**TECHNICAL EVALUATION REPORT
QUAD CITIES STATION UNITS 1 AND 2
STATION BLACKOUT EVALUATION**

Science Applications International Corporation
An Employee-Owned Company

Figure 1: Quad Cities Electrical One Line Diagram with AAC

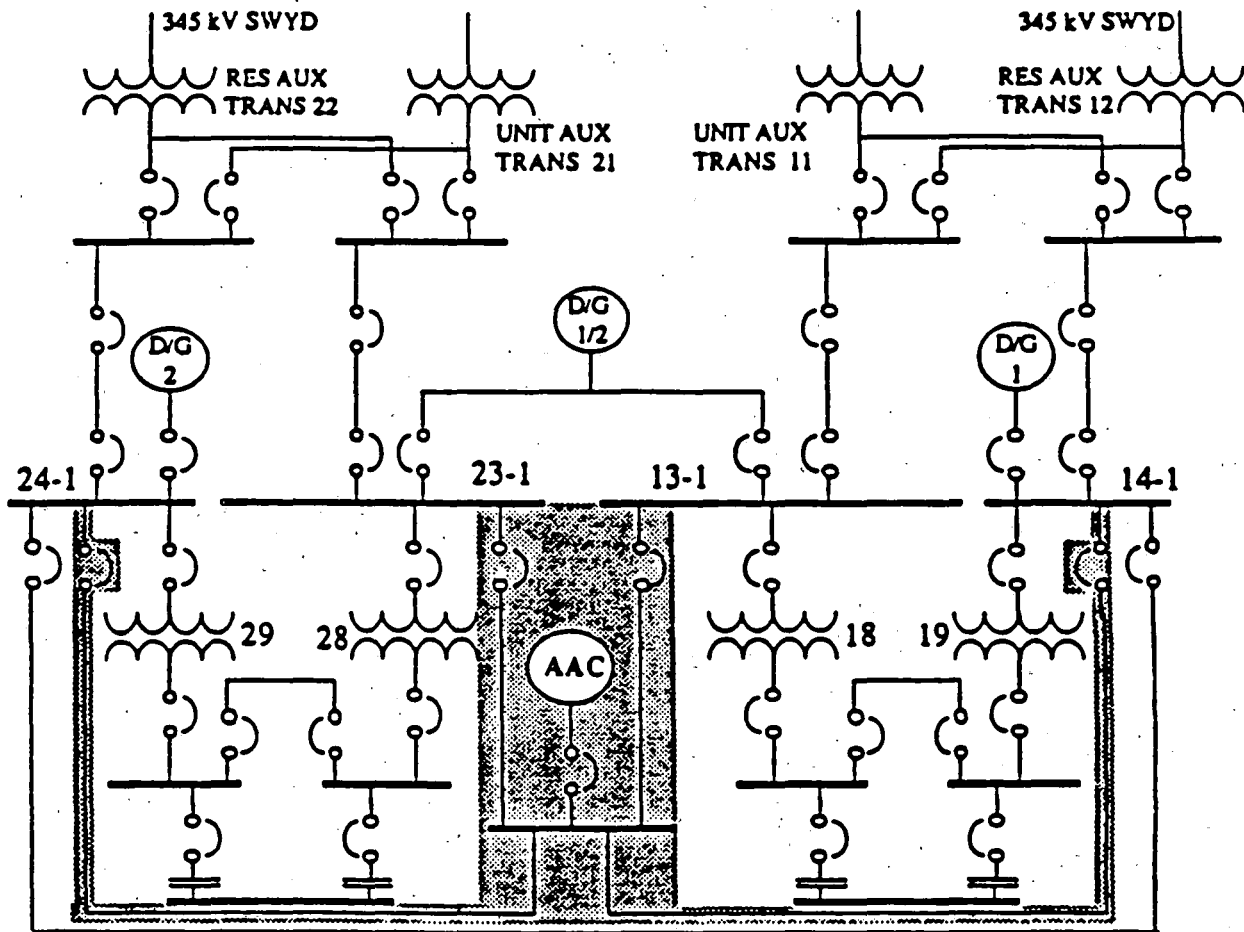
Although the licensee is committed to install an AAC which conforms to the guidance provided in Appendix B to NUMARC 87-00, it did not provide sufficient information to review the proposed modification. The only information supplied is that the AAC will be a non-class 1E diesel

generator with a 2000 hour rating of 5700 kW and that it would be available within one hour. With a capacity of 5700kW, the proposed AAC power source would produce twice the power of an EDG, hence it would be capable of powering one safety train of each unit simultaneously. This capacity is considered adequate.

The proposed circuits for connecting the AAC power source to the safe shutdown buses may be credited as the cross-tie between safety buses 23-1 and 33-1. However, all of the connections from safety buses 23-1, 24-1, 33-1, and 34-1 to the AAC power source output circuit breaker would have to be safety grade since all these circuits are directly connected to the AAC power source output breaker.

The detailed design of the AAC power source needs to be reviewed to verify that the requirements of NUMARC 87-00 Appendix B are met.
